DEPARTMENT OF CITY PLANNING

RECOMMENDATION REPORT

PROJECT LOCATION: 18430-18434 West Vanowen Street

Case No.: CPC-2022-8567-DB-CDO-SPR-VHCA
CEQA No.: ENV-2022-8568-CE
Incidental Cases: N/A
Related Cases: N/A
Council No.: 4 – Raman
Plan Area: Reseda – West Van Nuys
Specific Plan: N/A
Certified NC: Reseda
GPLU: Community Commercial
Zone: [Q] C2-1L-CDO-RIO, RA-1L-RIO
Applicant: Daniel Kashani,
18434 Vanowen LLC
Representative: Olivia Joncich
Rand Paster & Nelson, LLP

WEST ELEVATION

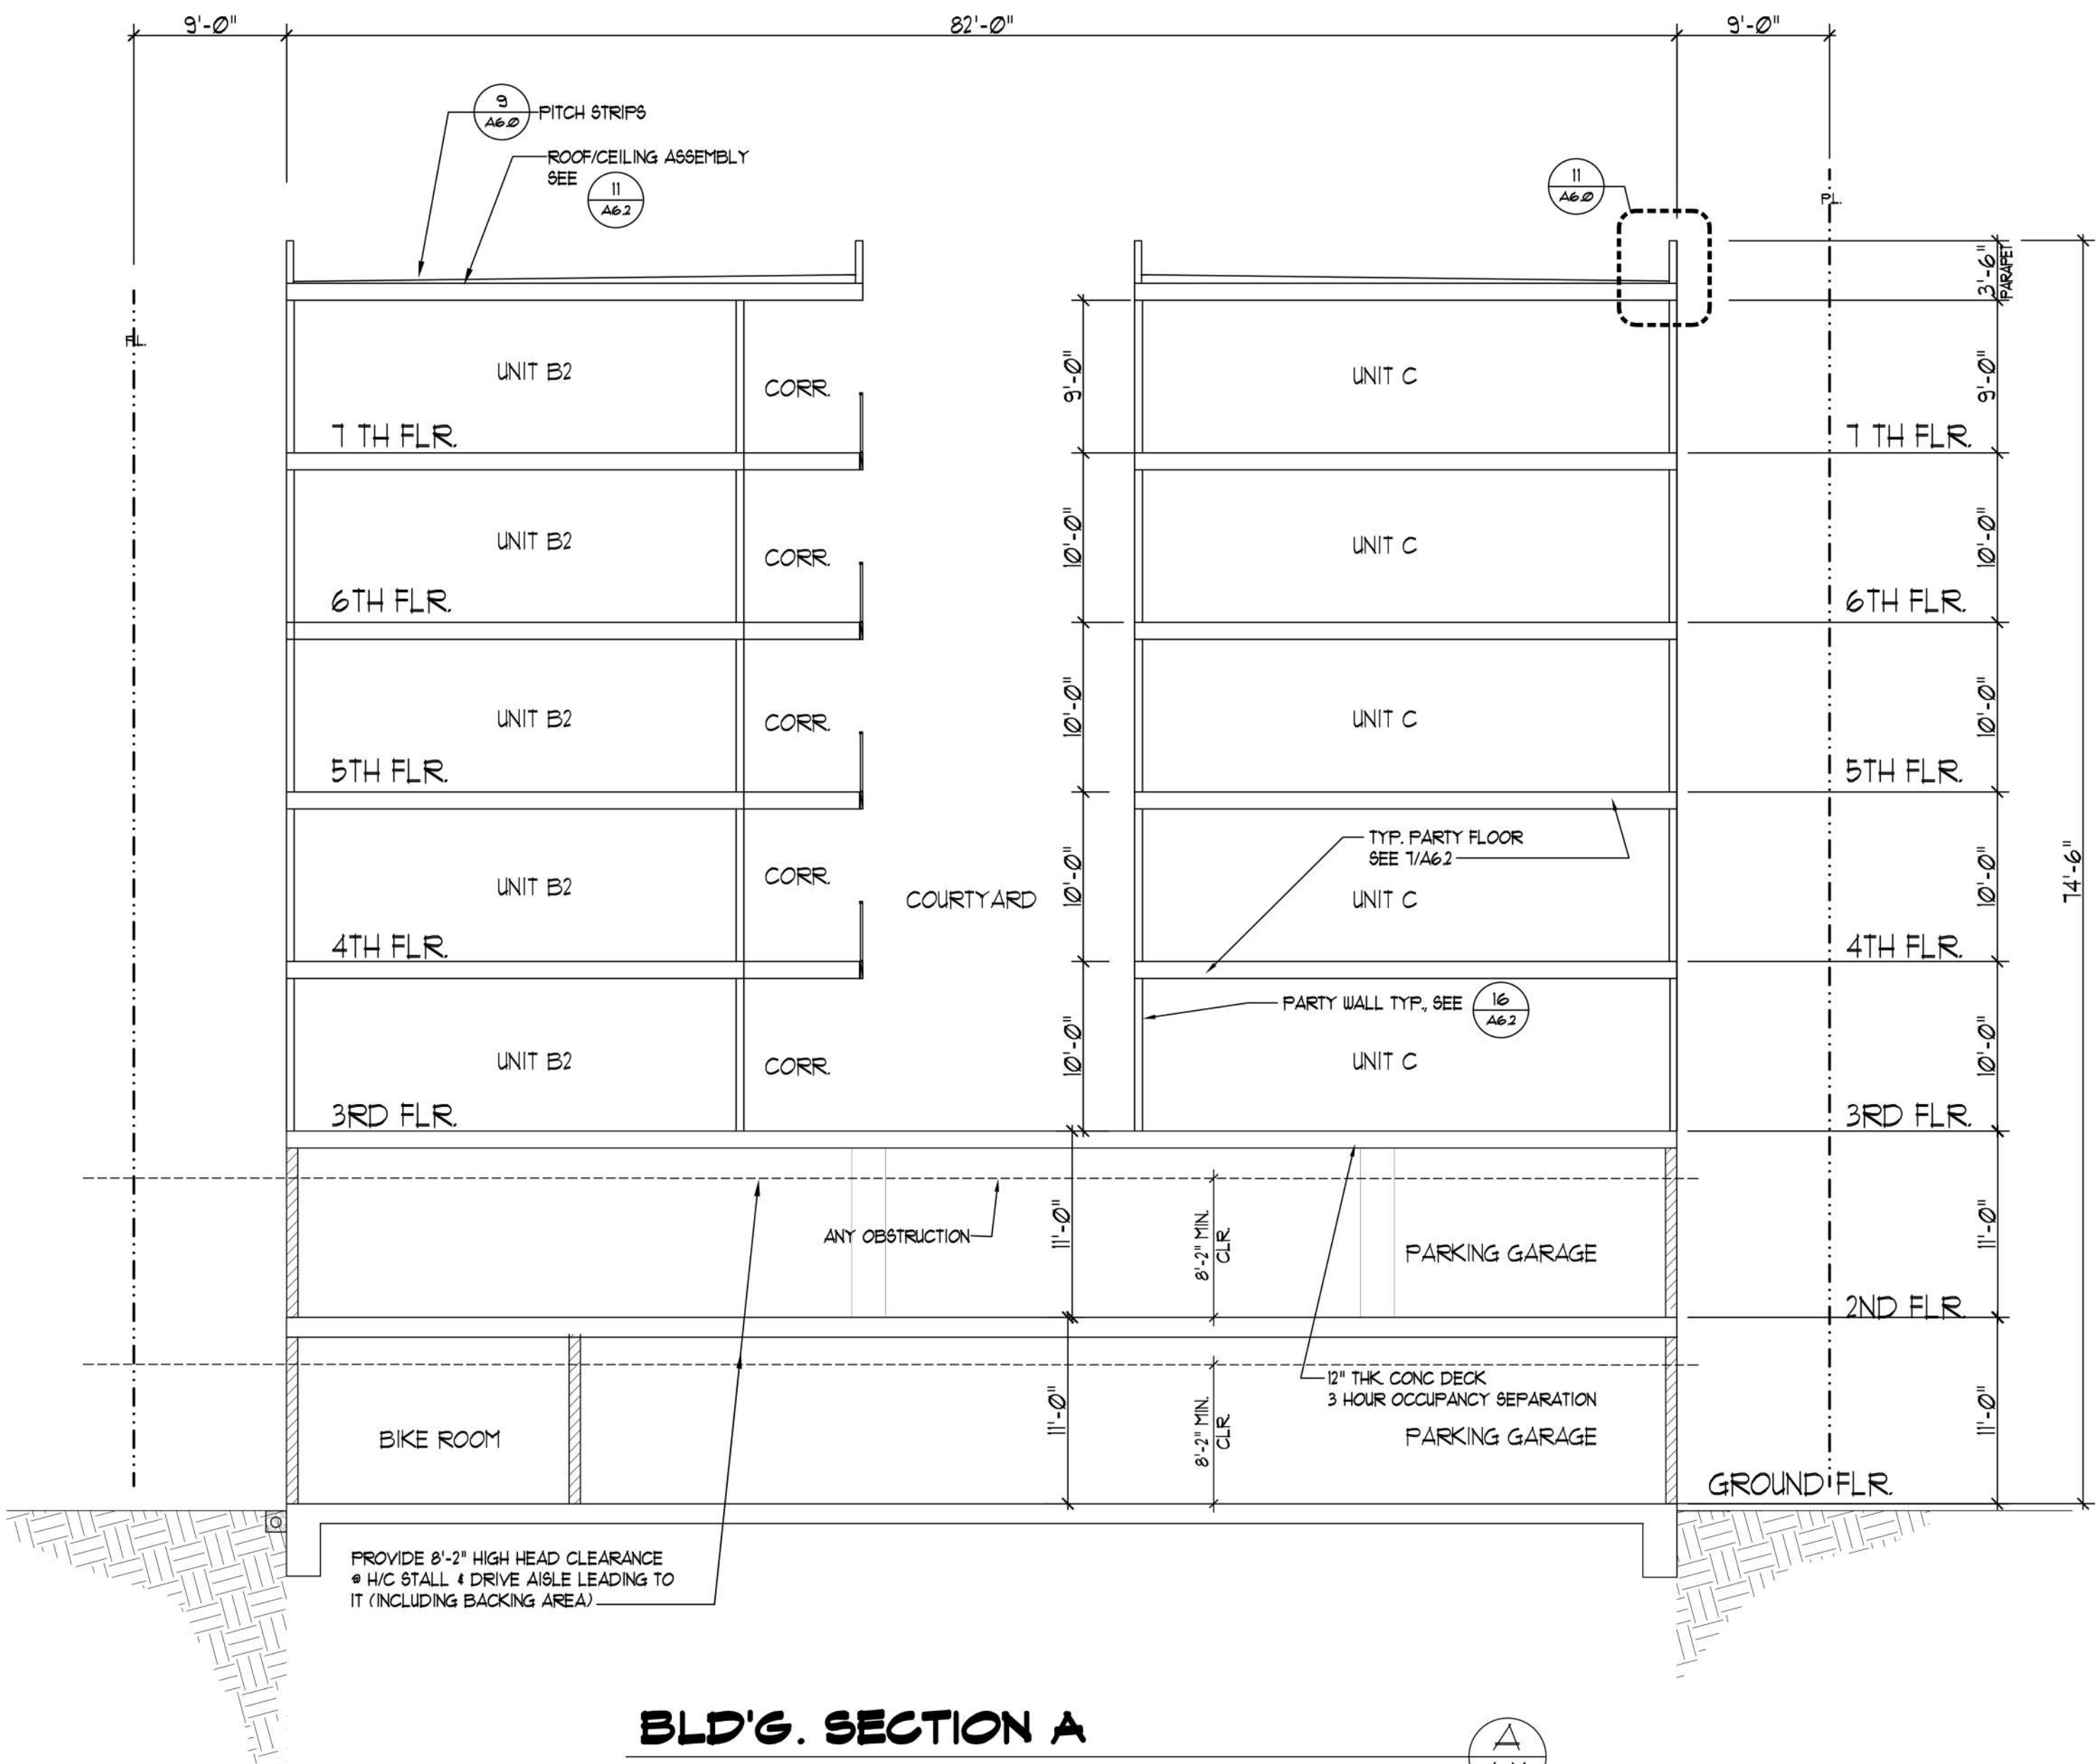
The PVP recommended that the Applicant provide more articulation and use of a variety of building materials along the west elevation. Compared to the north, east, and south elevations, the west elevation lacks visual interest and design components that are important for creating an attractive design that is compatible with existing and future development of the surrounding neighborhood. The PVP also recommended that the planters portrayed along the lobby entrance be replaced with in-ground landscaping to

provide a less bunker-like quality for pedestrian, the Project's car ramp descending into the subterranean parking level be consistent with the Department of Building and Safety's (DBS) turning/back-up template, and the plans and elevations be made consistent showing the location of planters, bicycle parking, and the transformer.

Regarding the PVP's comment on the Project's west elevation, the Applicant submitted a revised plan set that incorporates roof line variation which wraps around the front and rear façades, utilizes muted tones of color variation which de-emphasizes the project scale and breaks up the length of the building, and stucco siding to enhance building articulation. The landscape plans have been revised to remove the planters flanking the lobby entrance and instead provide in-ground landscaping as recommended. With regards to the car ramp, the car ramp has been designed per DBS's turning/back-up template which will be verified during plan check. The Applicant also revised the plan set to ensure the plans and elevations are consistent in portraying project design features.
